# HAY CREEK VALLEY

## FINAL DRAINAGE REPORT

EPC STORMWATER REVIEW COMMENTS  
IN ORANGE BOXES WITH BLACK TEXT

Project No. 22.886.076

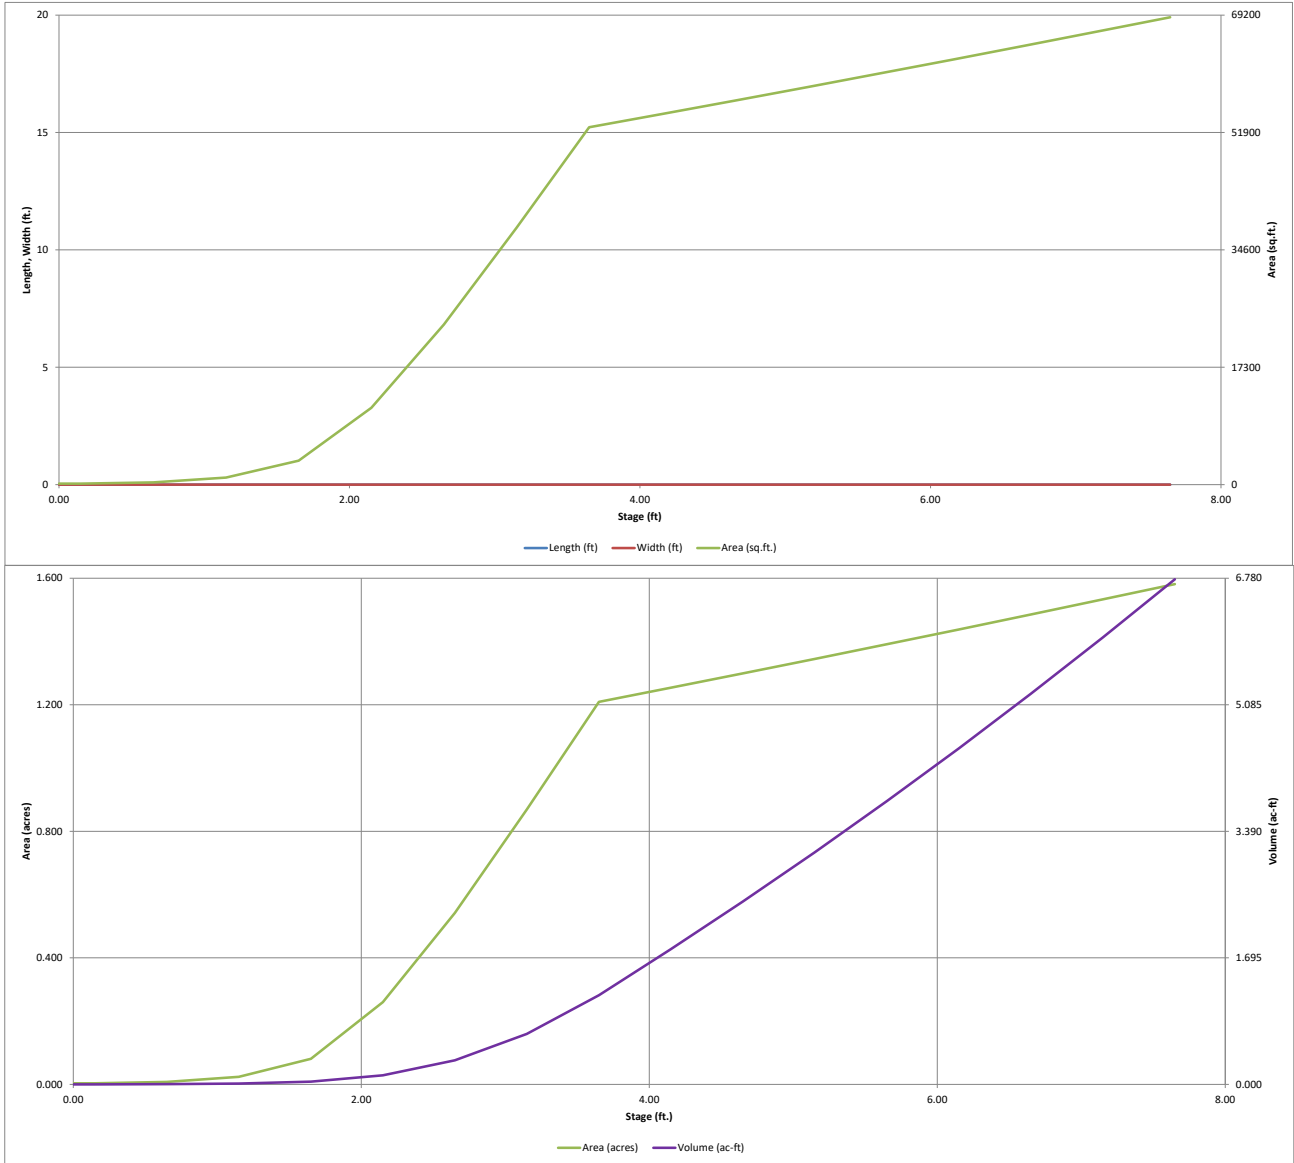
why was the WQCV overridden? Please add a note stating why.

Figure 3- Q5 OUTFALL SUMMARY

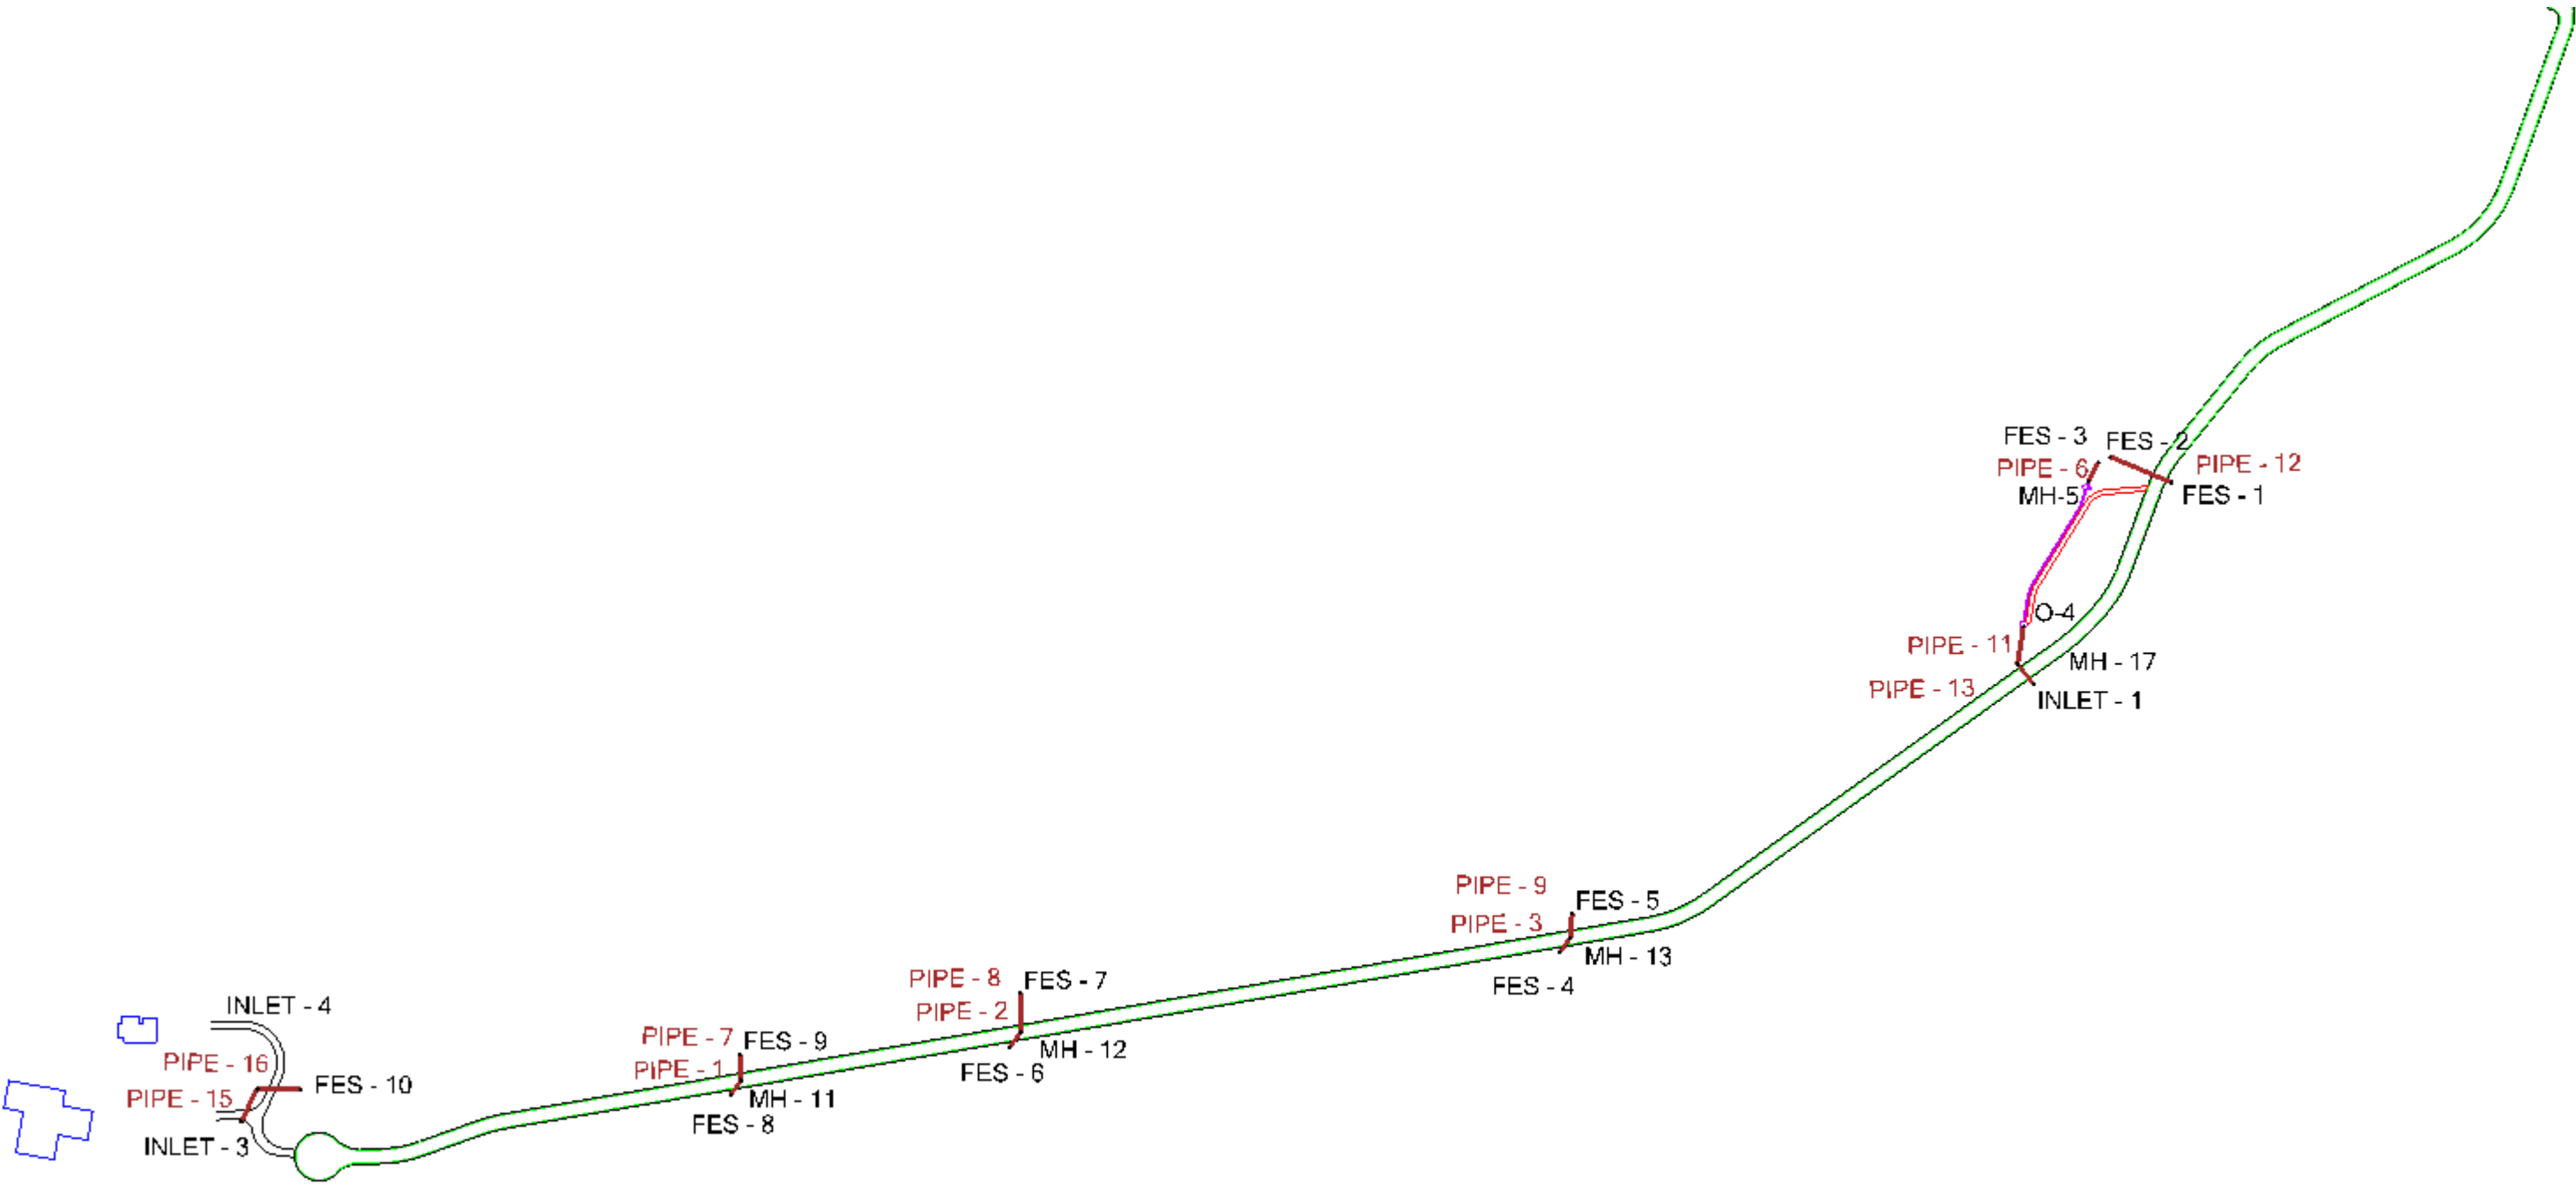
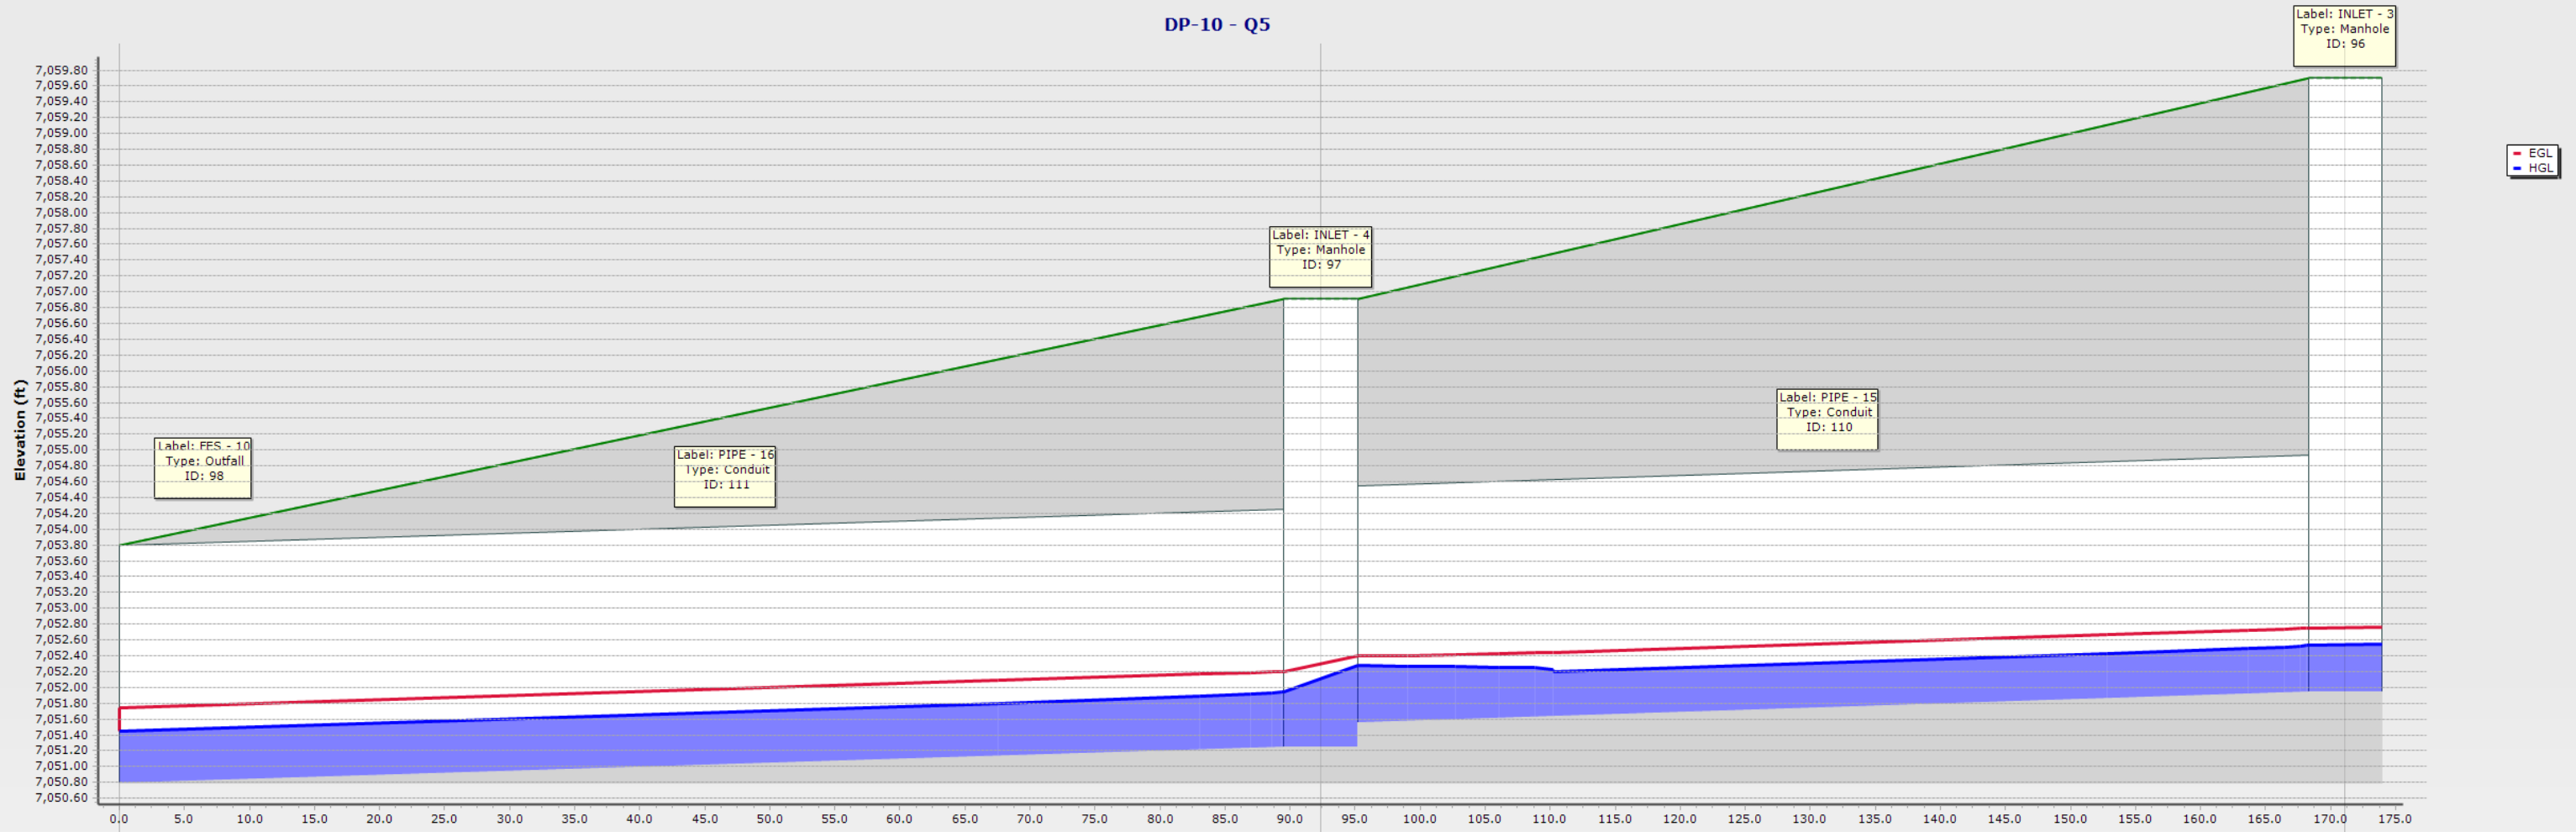
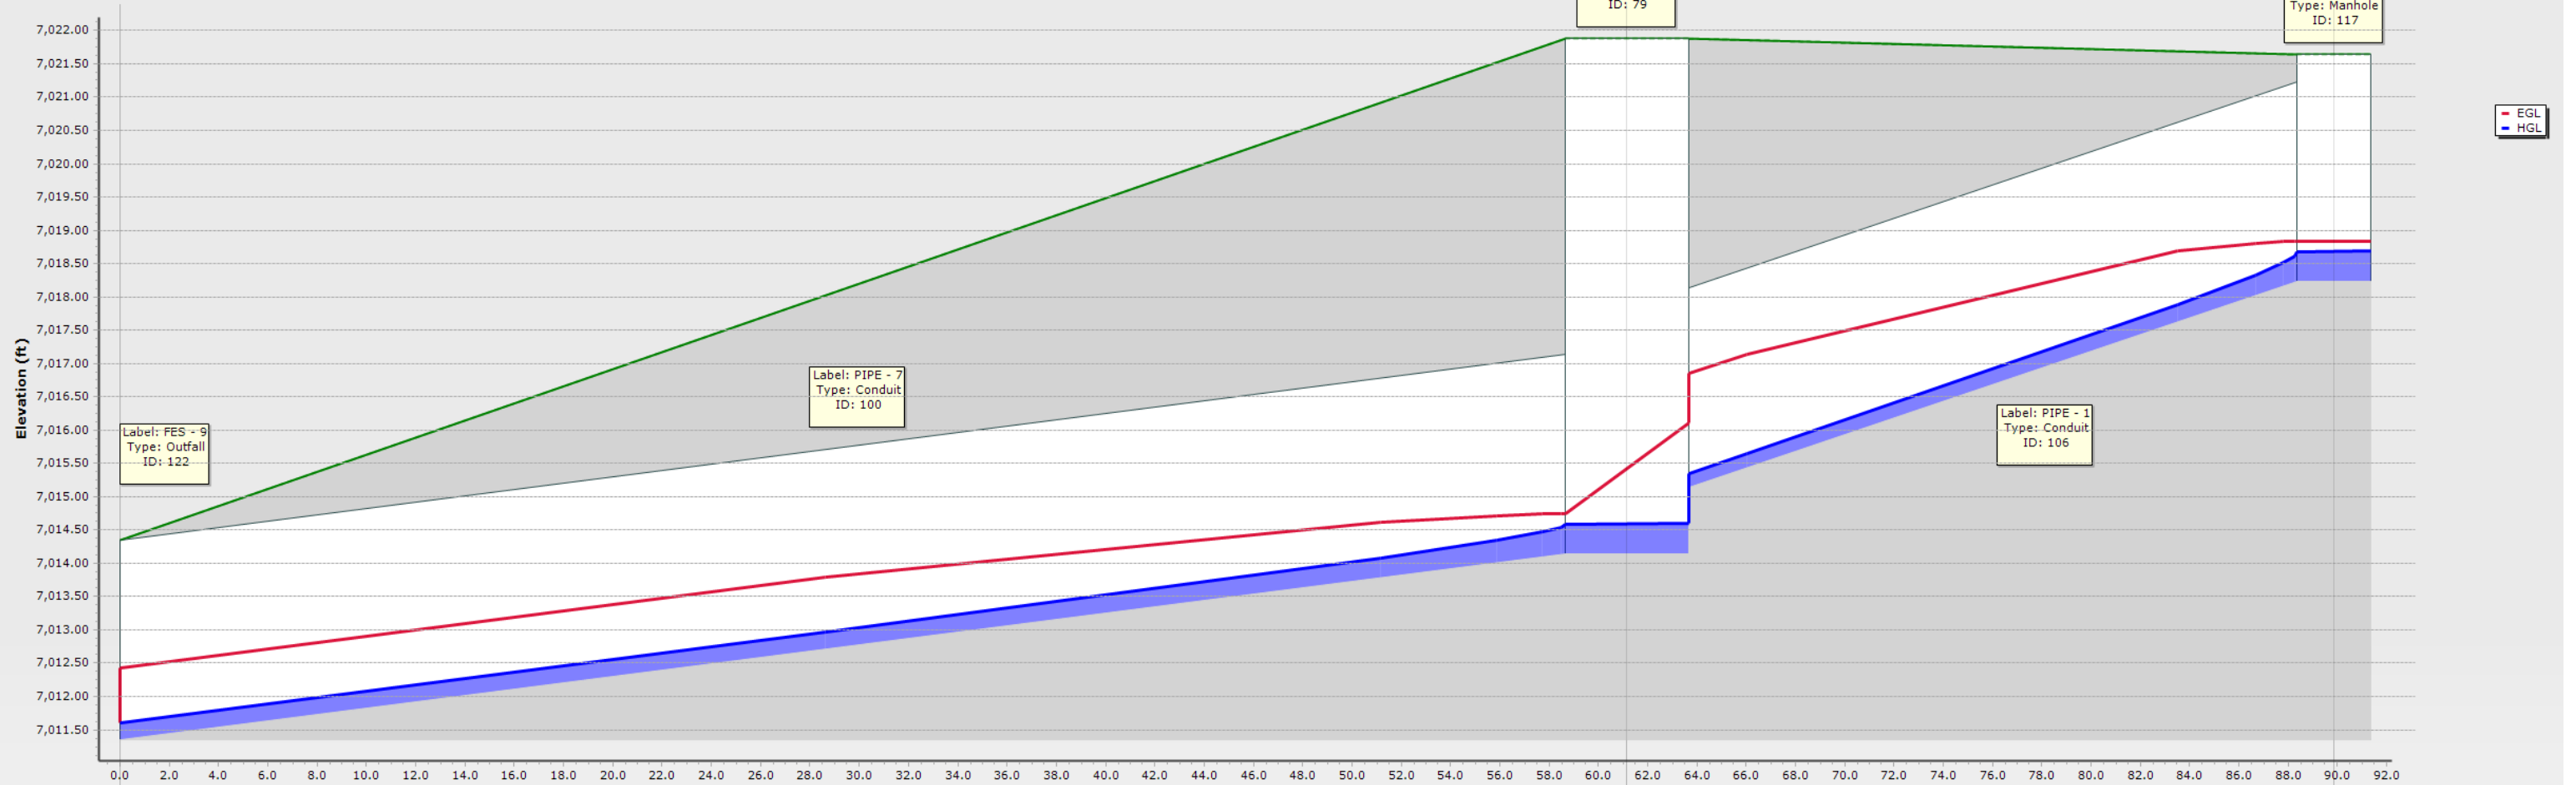
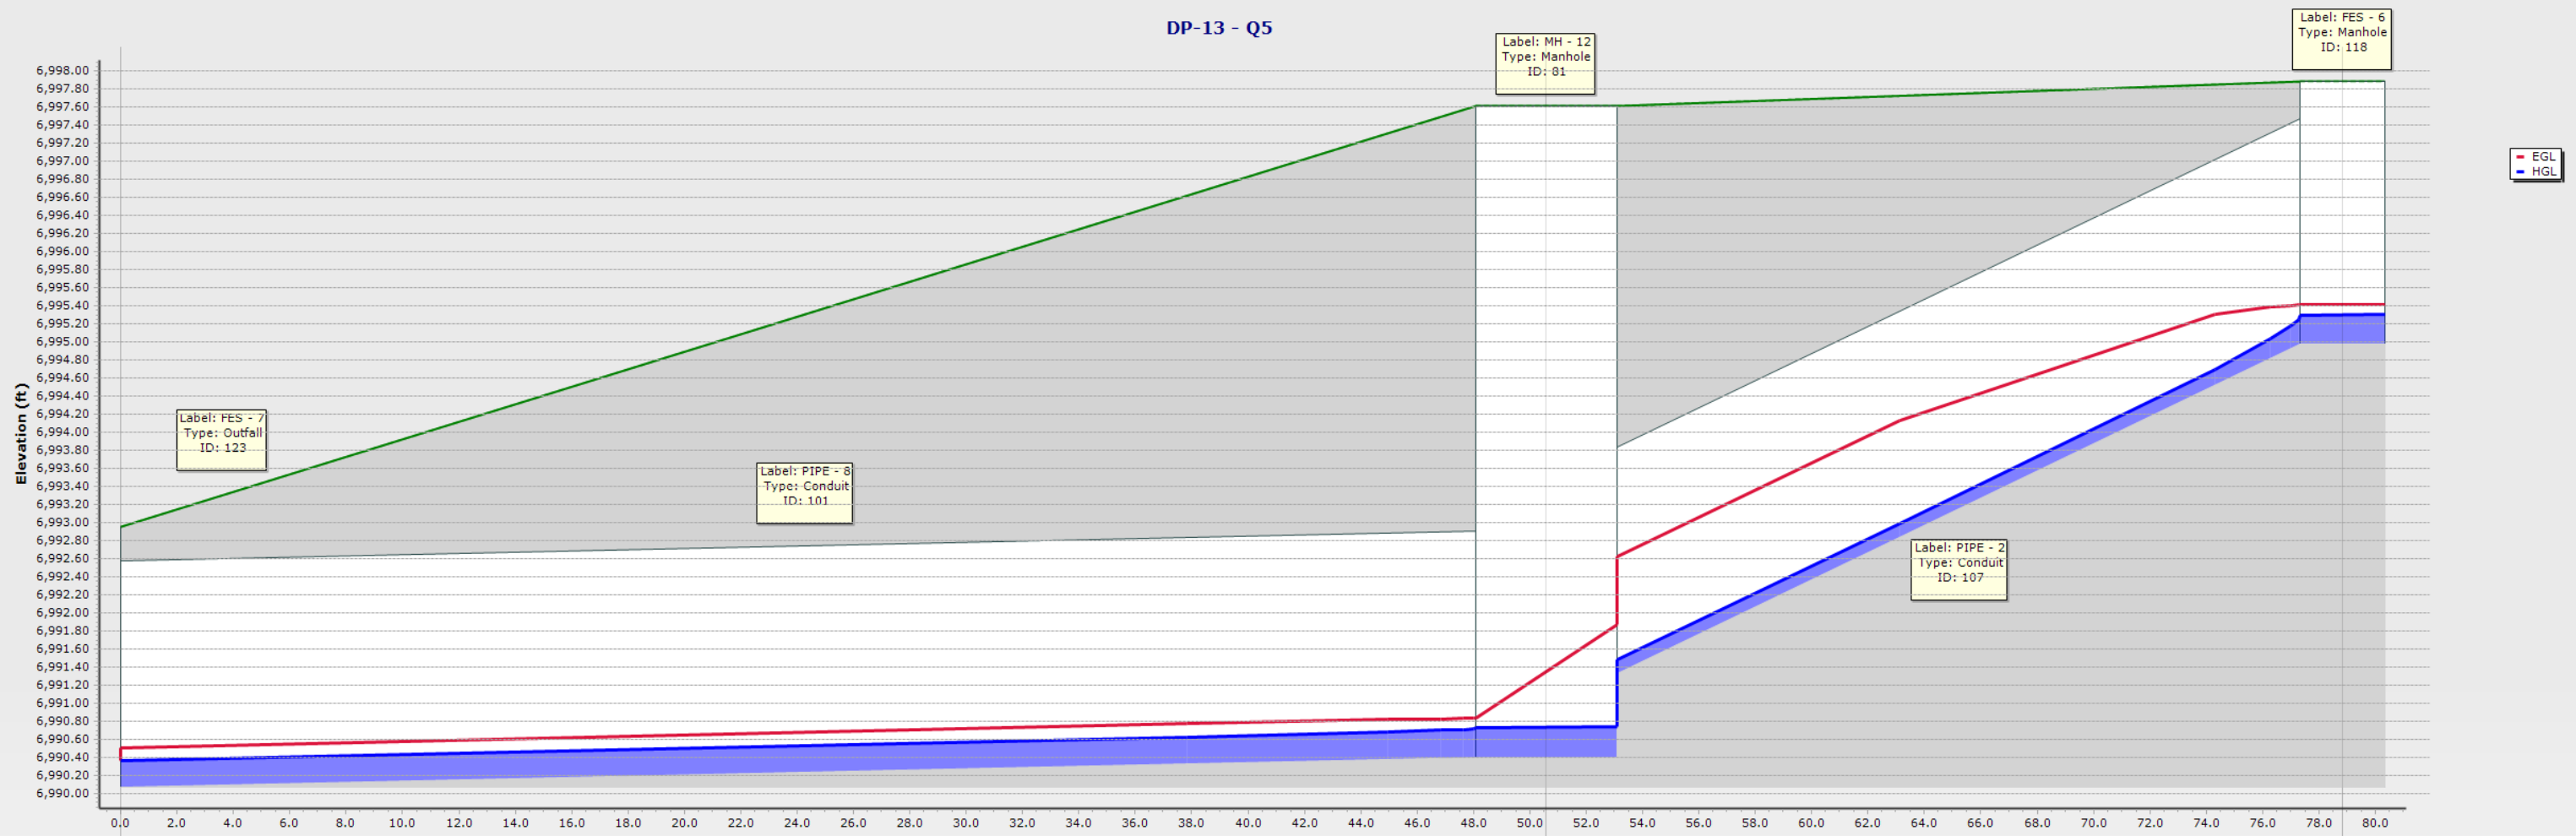
why is free outfall selected and tailwater is not analyzed for 6 of the 7 storm drain outfalls? If there's a reason please add a note/discuss.
